SERVICE BULLETIN: JSB 012-6

Issue: 6

Date: 11th September 2020

Subject: Jabiru Engine Flywheel Attachment

Figure 2 - Plain washers compared to Nordloc washers

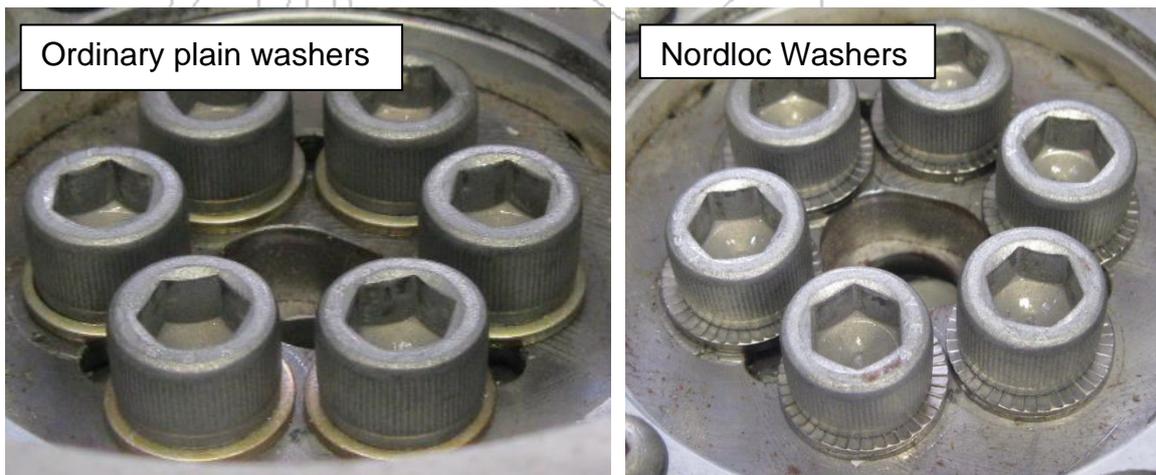
Flywheel screws must now be installed using Nordloc washers (replacing the previous installation which used either plain or Belleville washers). Jabiru engines of any and all flywheel configurations (as defined in Table 1) should now use Nordloc washers. These washers are easily identified via visual inspection as shown below in Figure 2.

Refer to the Jabiru Engine overhaul manual JEM0001 (always check for the latest revision) for the installation procedure of flywheel capscrews using Nordloc washers. The major difference in installation is that bolts installed with Nordloc washers **must not be installed with Loctite**. The torque setting is also different for capscrews installed with these washers.

When Nordloc washers are used on an aluminium surface a steel plate must be used to protect the aluminium surface. These are available from Jabiru.
